8.11 Consented and Proposed Comparison Elevations

East Block

KENAVON DRIVE - CONSENTED AND PROPOSED ELEVATIONS COMPARISON

Kenavon Drive
East Block Courtyard East
Elevation 1

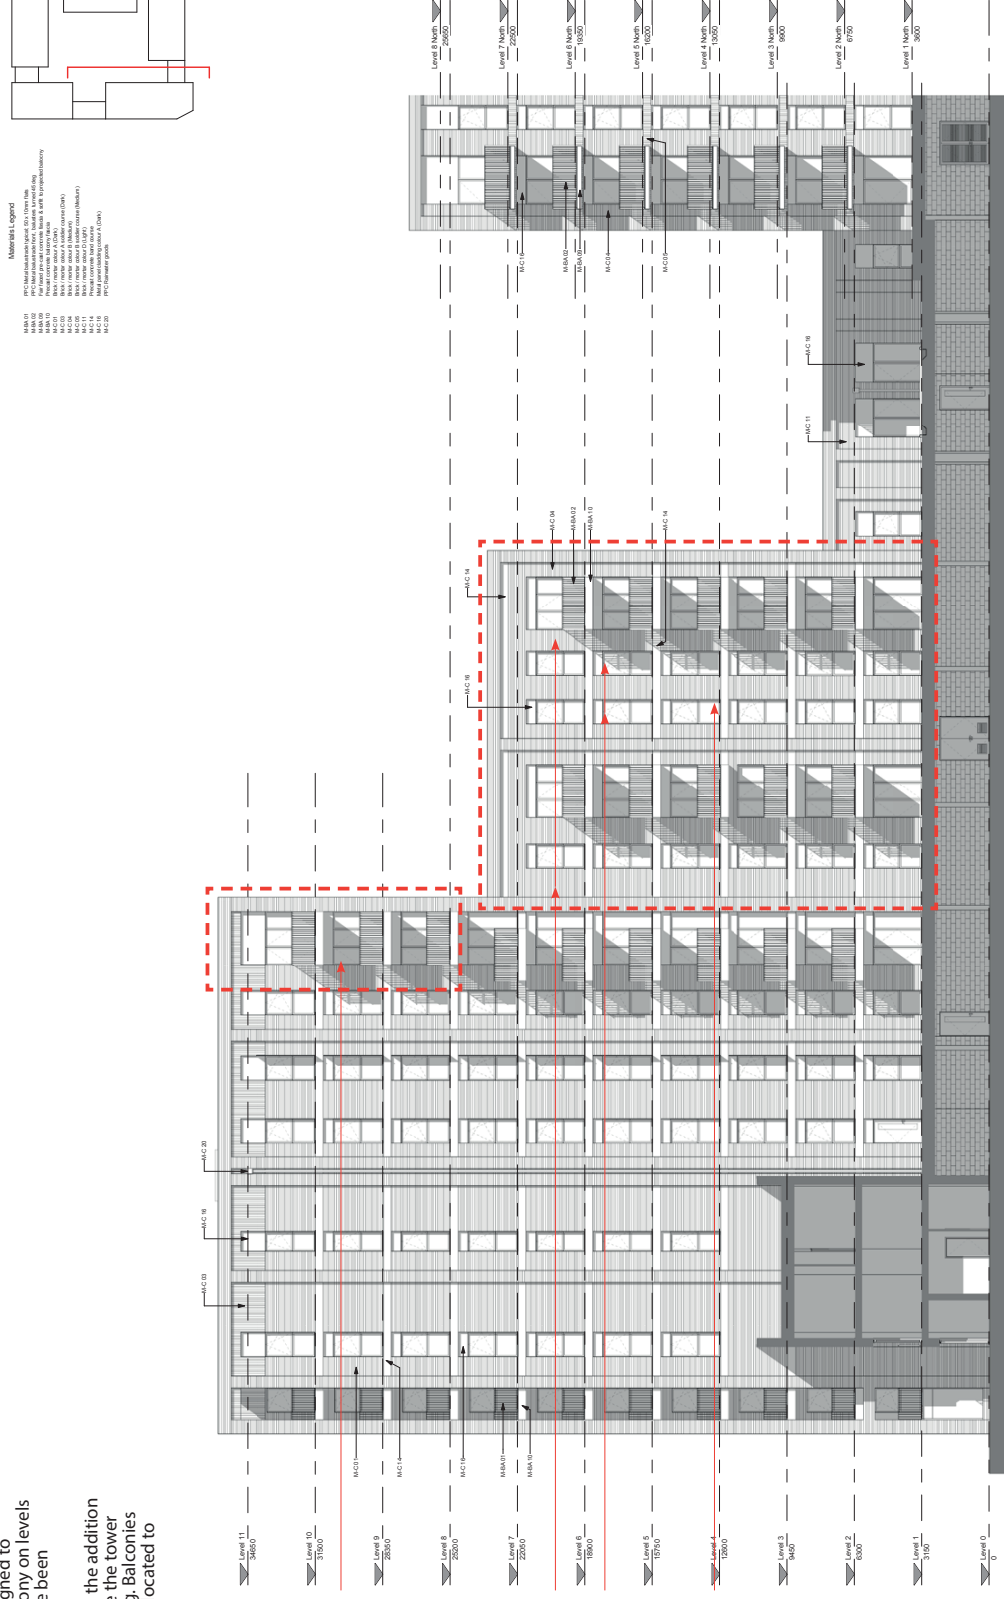
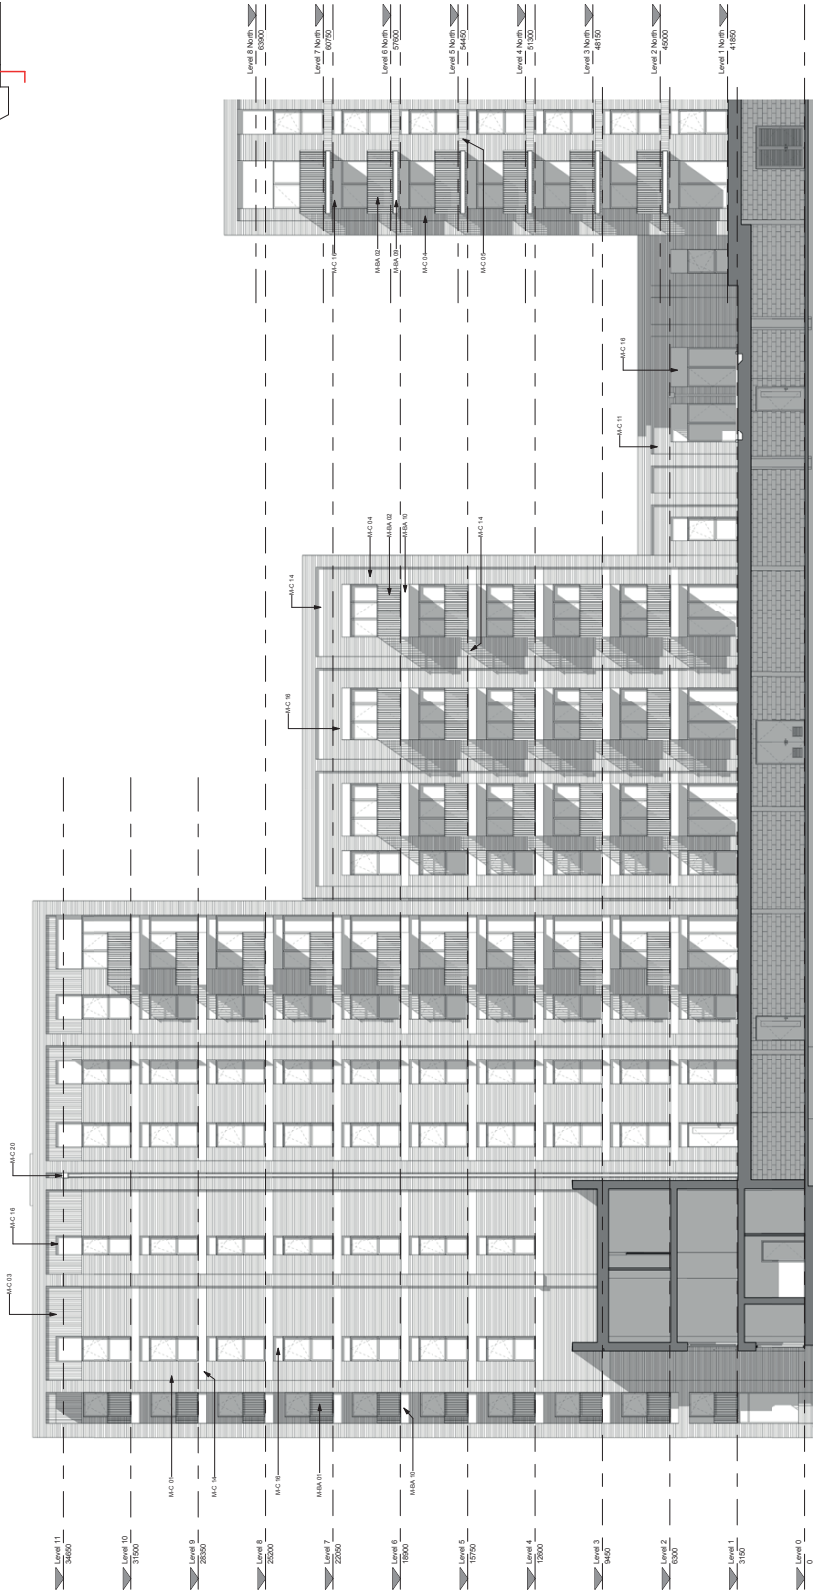
This facade has been redesigned to include one additional balcony on levels 2 - 6. As such, windows have been replaced by a balcony door.

Other amendments include the addition of one brick pier to separate the tower from the rest of the building. Balconies on levels 8-10 have been relocated to align with ones levels 2-7.

Balconies relocated to align to ones on the levels below

Brick piers added

Windows replaced by balcony door

Balconies added

Kenavon Drive
East Block Courtyard East
Elevation 2

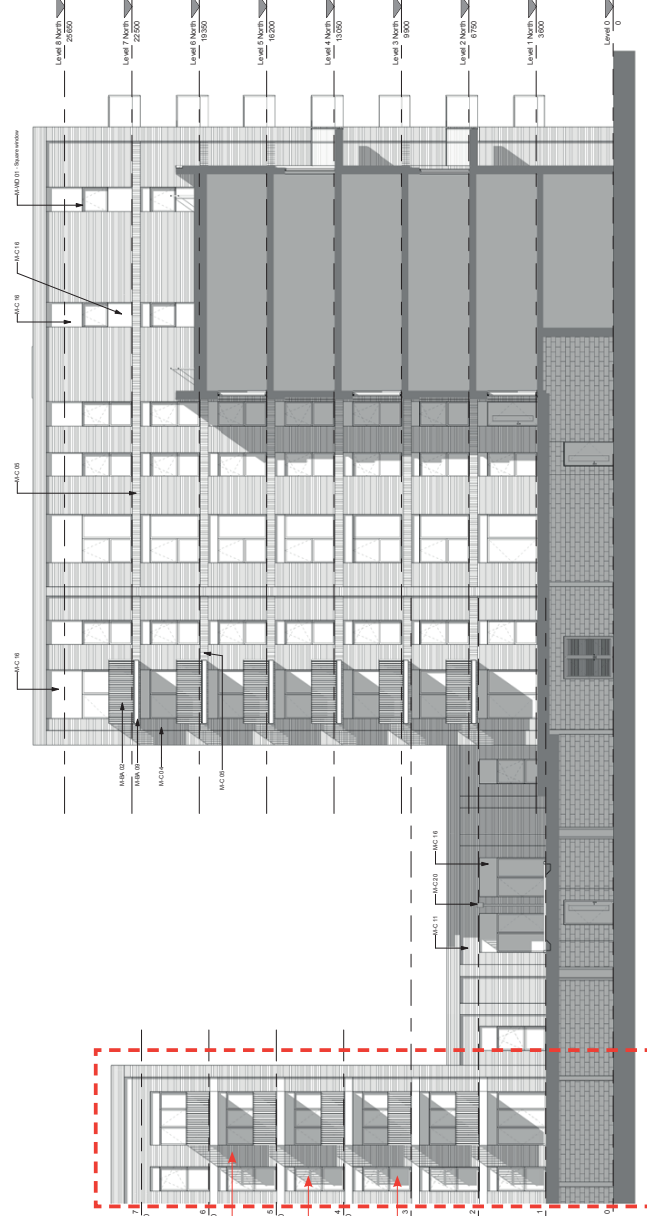
Brick pier added

Balcony added

Windows replaced
by balcony door
